LEARNING RESOURCES CENTER
BUILDING 'D' AND 'CR' REMODEL

VENTURA COLLEGE

September 24, 2001
KBZ Job No. 93-18

INSPECTOR COPY

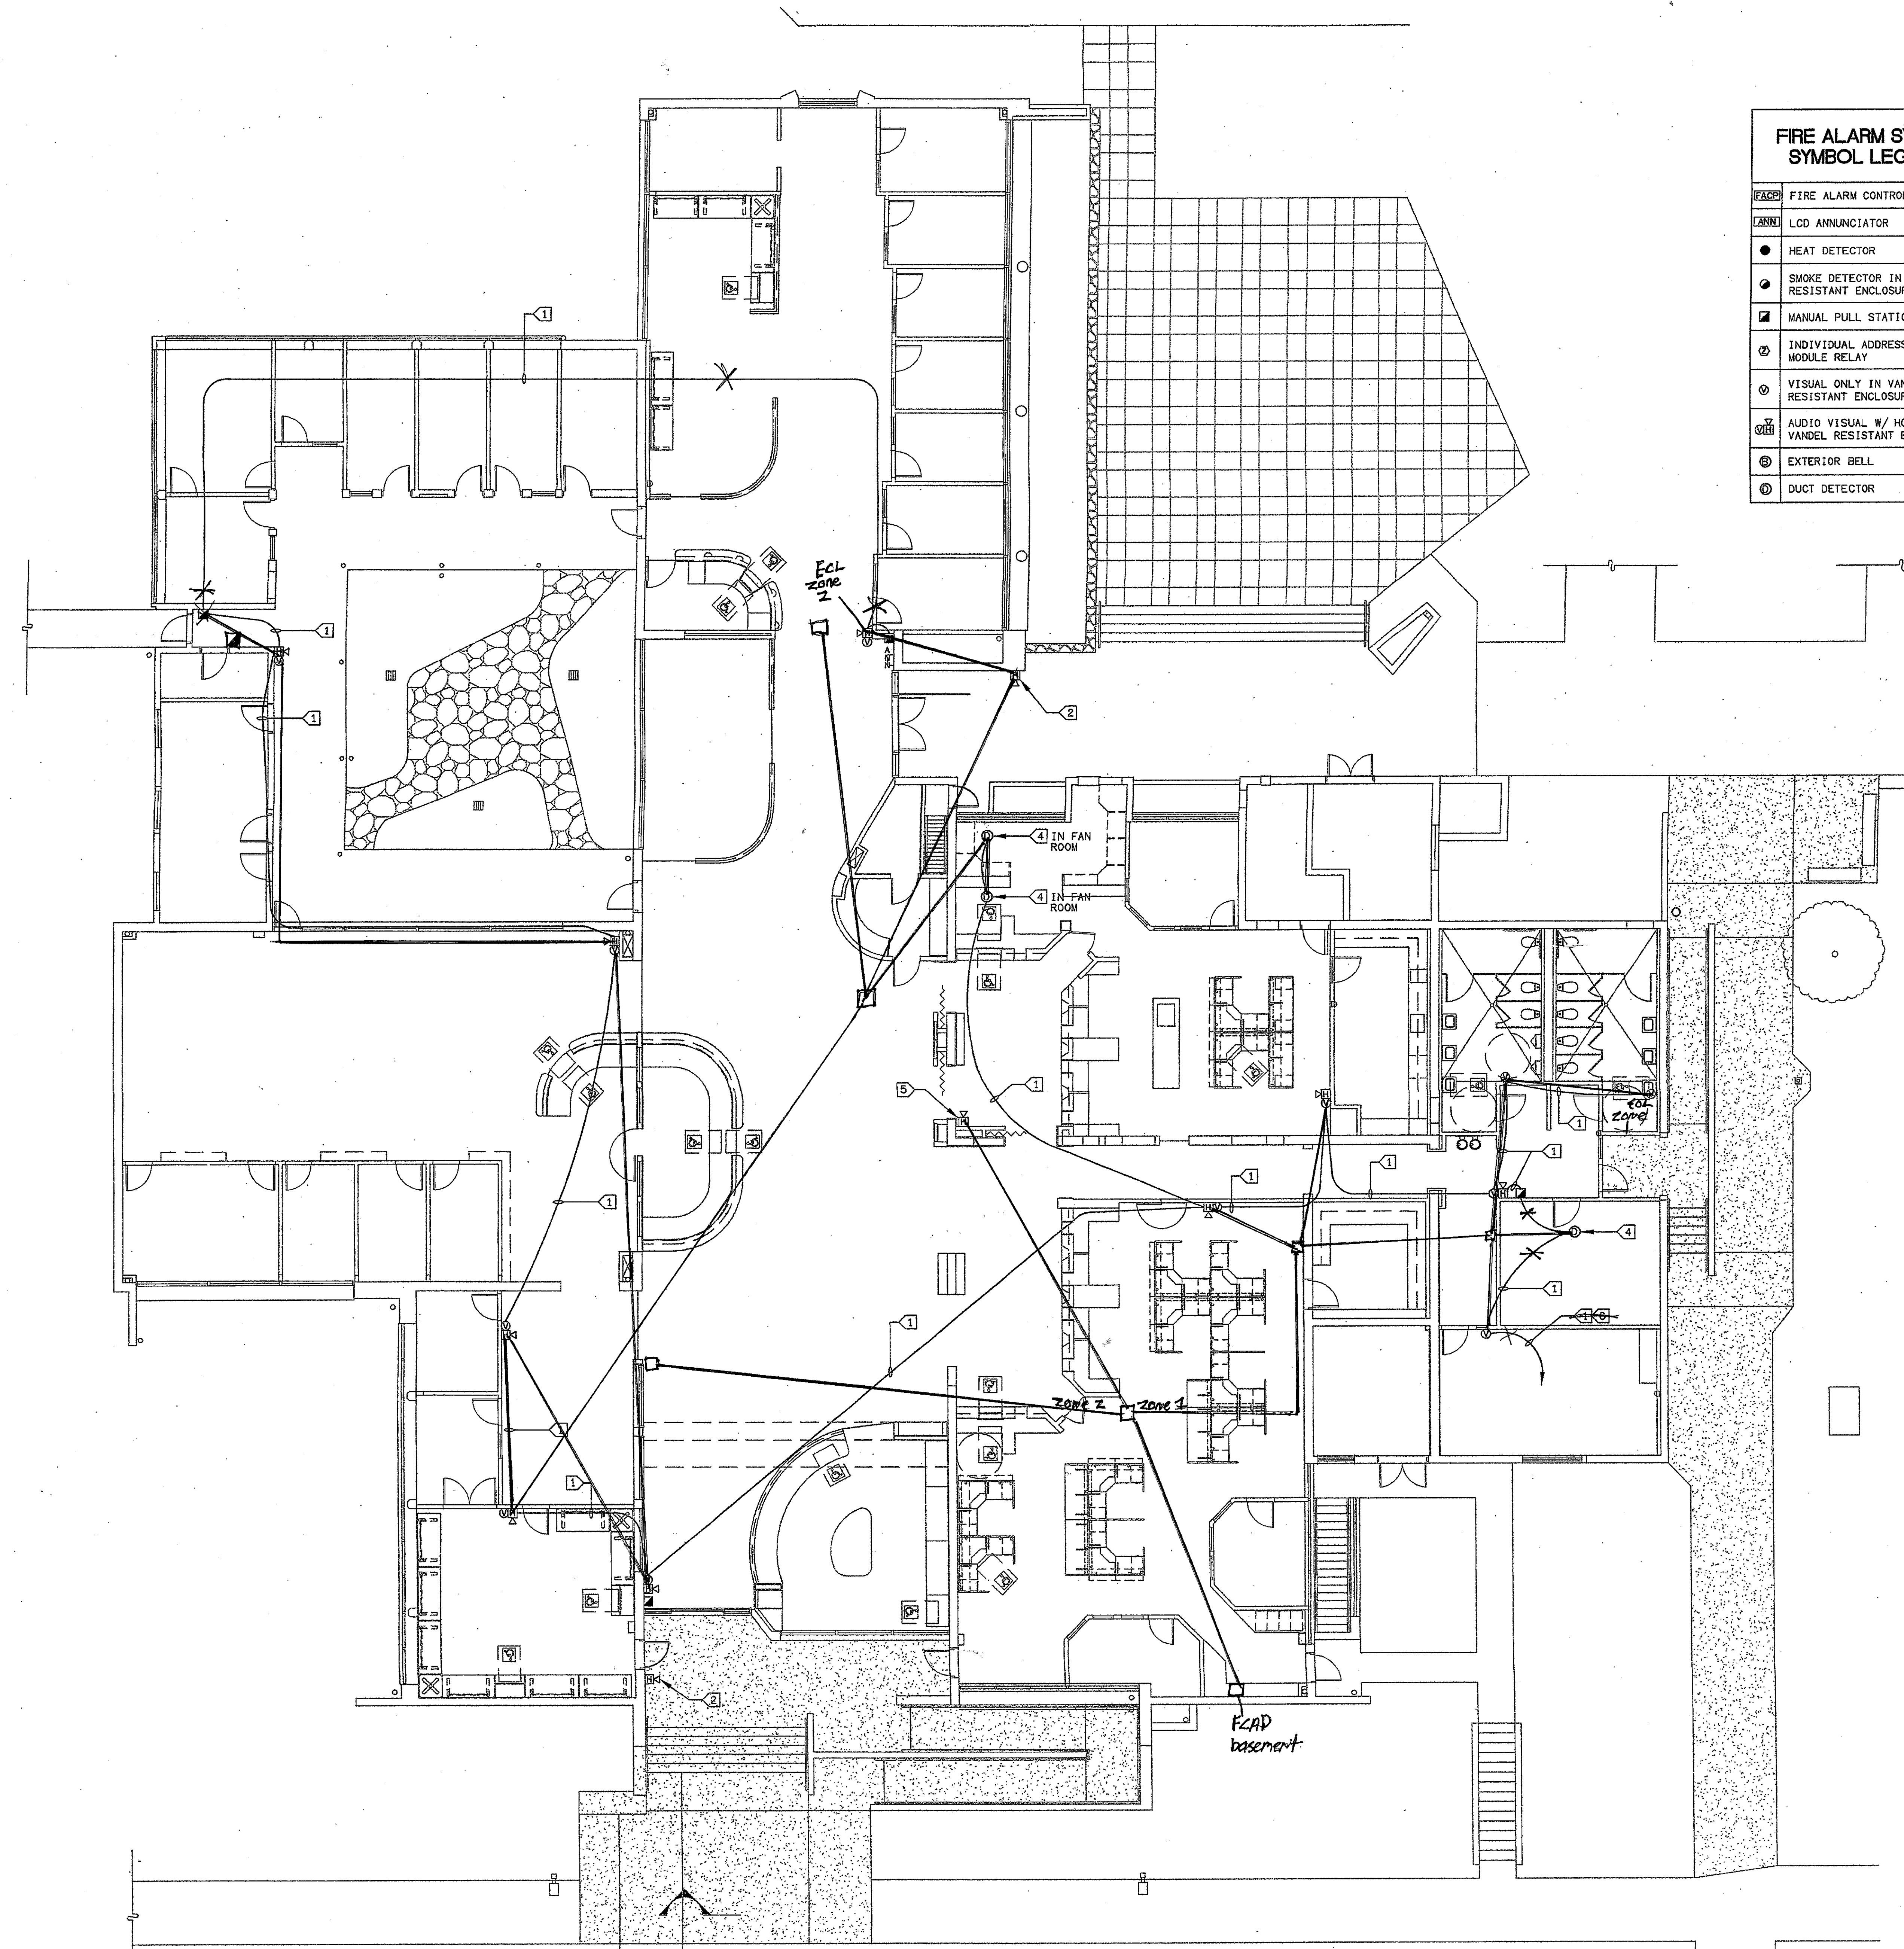
ITEM 10. Drawing Sheet E-500:

- Contractor shall provide surface mounted Wiremold #NM2000 series raceway and box system solution where conduit is required by existing field conditions to be surface mounted. Application locations include but are not limited to atrium exit door (near room 117) and southwest corner of lobby 101.
- Fire alarm conduits from room 124 to room 128 and from room 114 to room 113 shall transition room 124 & 114 ceiling cavity to room 128 & 113 higher ceiling through existing concrete wall via recessed j-boxes mounted in furred wall at West Side Room 128 and in intersecting east wall of Room 113. In no case shall conduit be routed on exterior of building.

ER-07
SHEET E-600

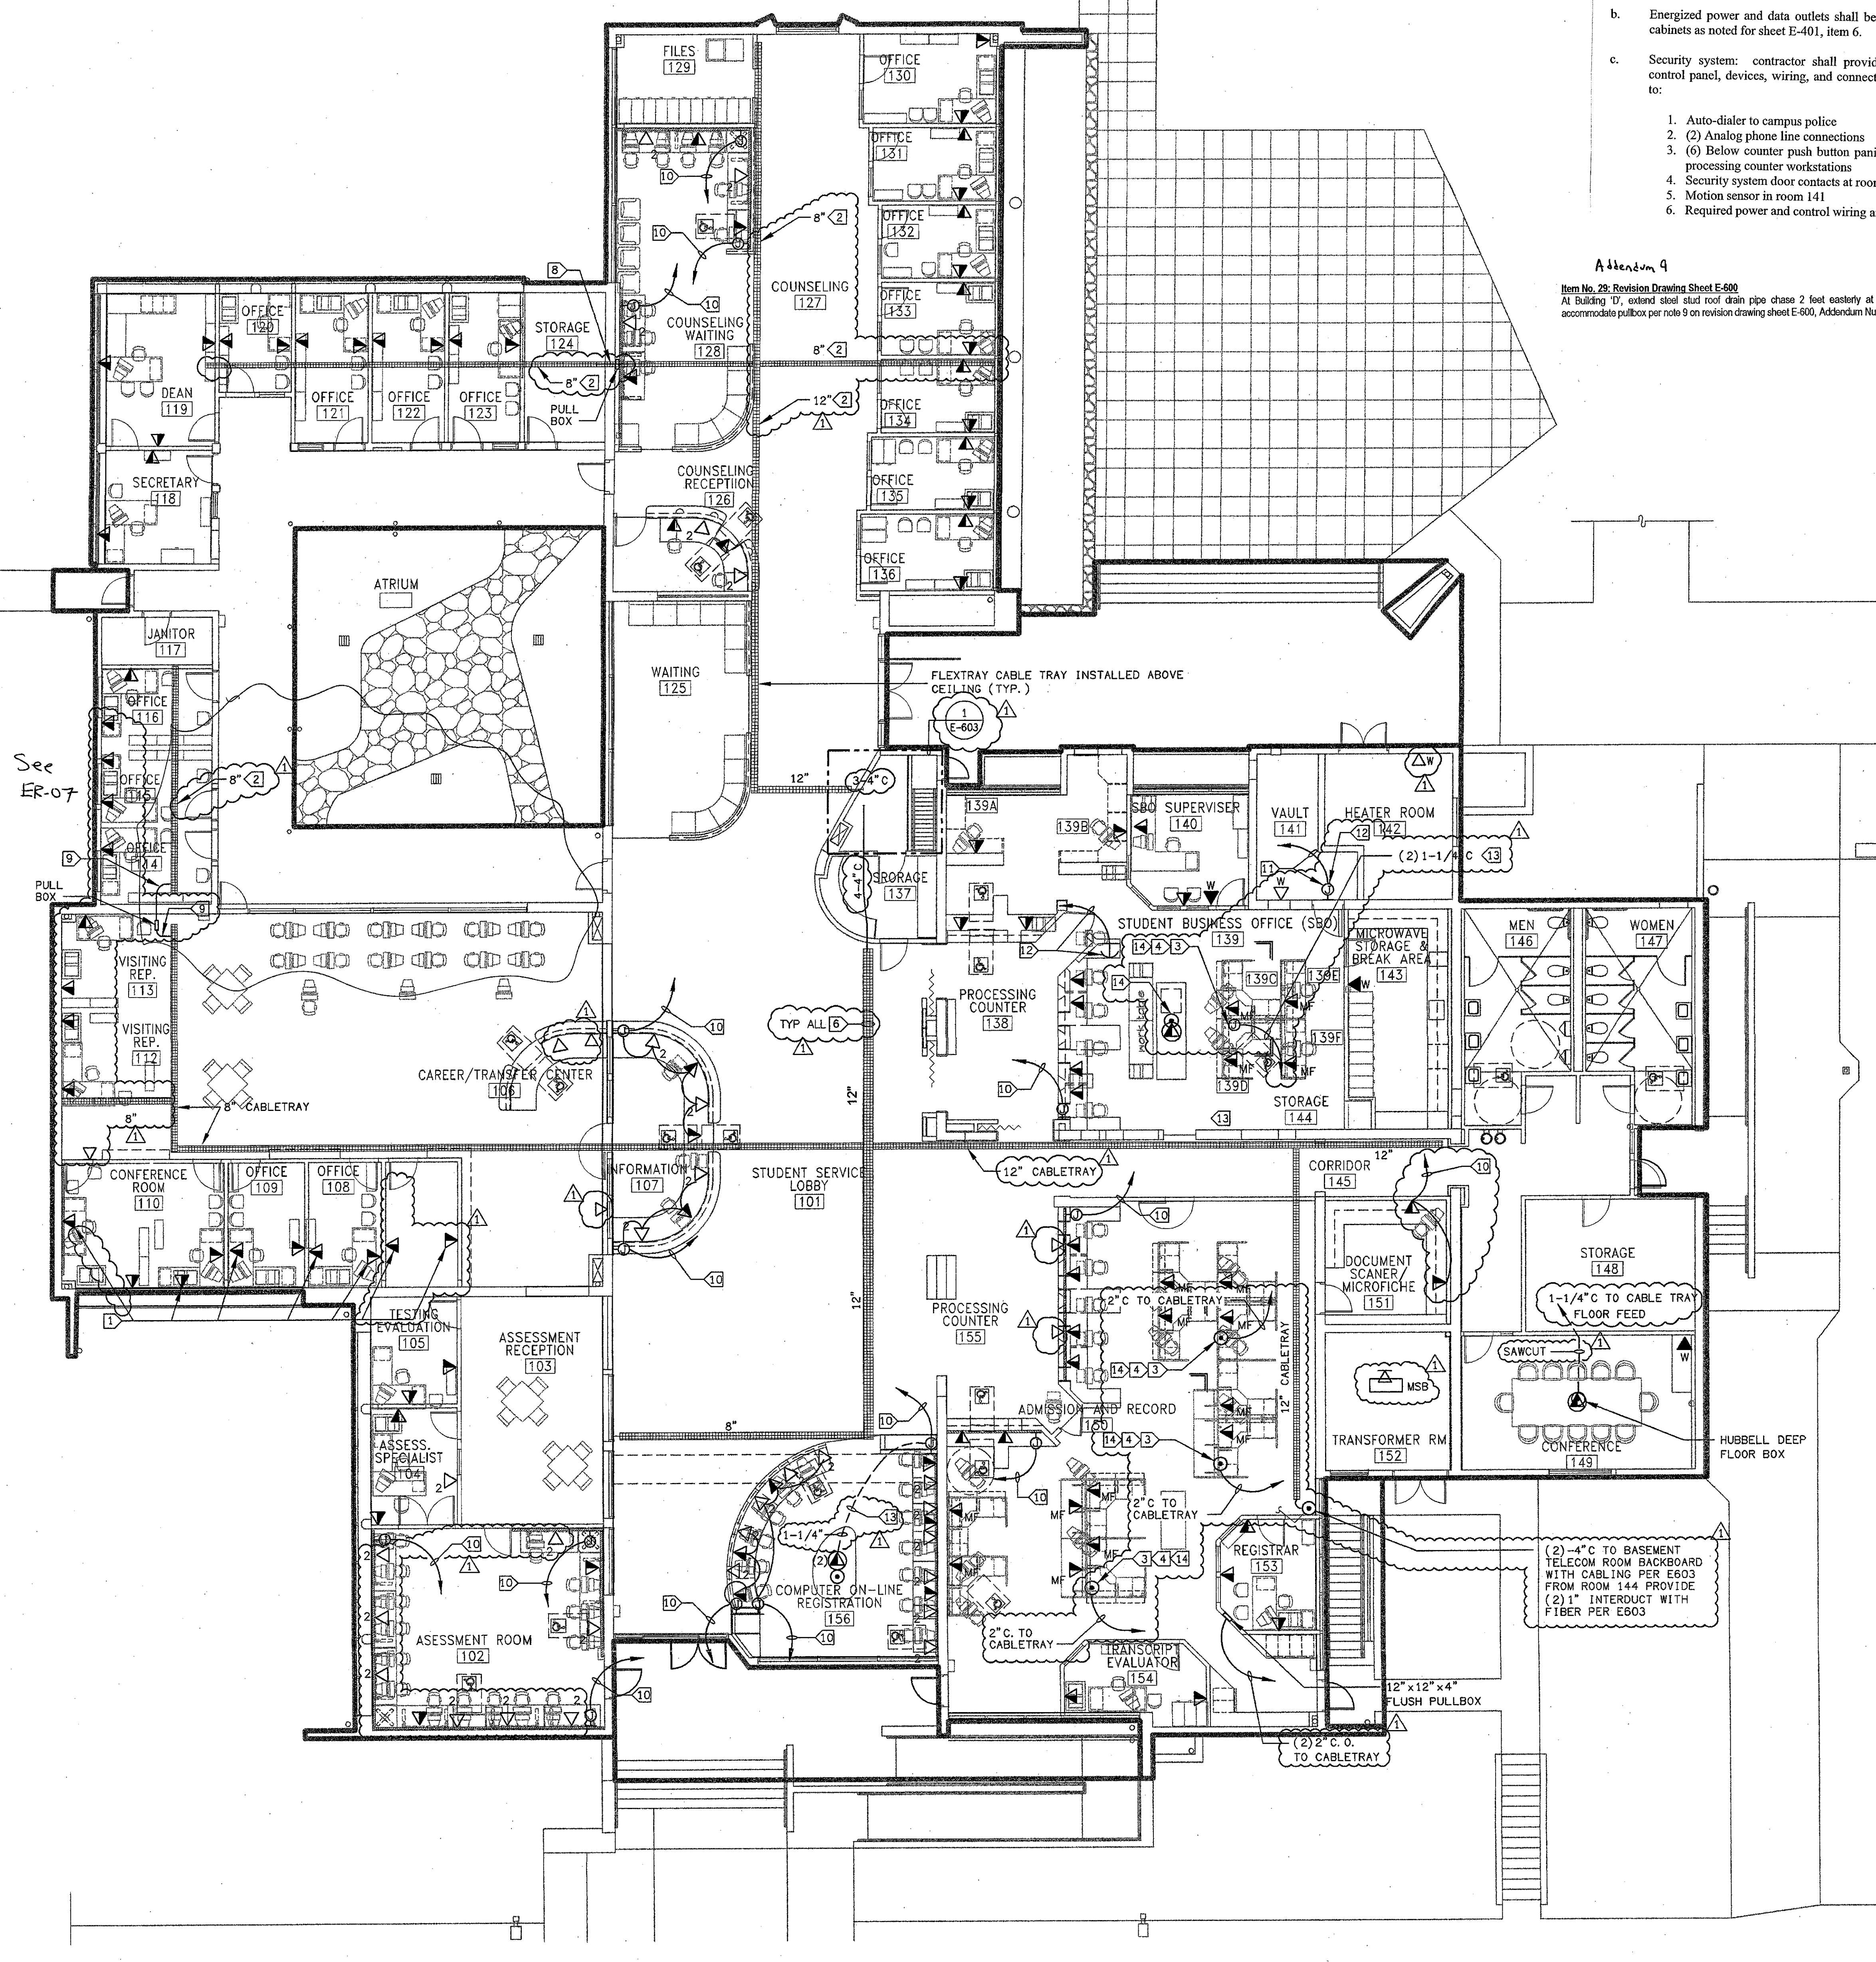
ITEM 11. Drawing Sheet E-600: **ADDENDUM 2**

- Power and communication raceways shall be provided as shown on drawing E 401.
- Energy power and data outlets shall be provided at end of peninsula cabinets as noted for sheet E-401, item 6.
- Security system: contractor shall provide addressable security alarm control panel, devices, wiring, and connections including but not limited to:
 - Auto-dialer to campus police
 - (2) Analog phone line connections
 - (6) Below counter push button panic alarm stations at room 139, processing counter workstations
 - Security system door contacts at room 141 vault door
 - Motion sensor in room 141
 - Required power and control wiring and connections.

Item No. 29: Revision Drawing Sheet E-600
At Building 'D', extend steel stud roof drain pipe chase 2 feet easterly at northwest corner of Career Center 106B to accommodate pull box per note 9 on revision drawing sheet E-600, Addendum Number 5.
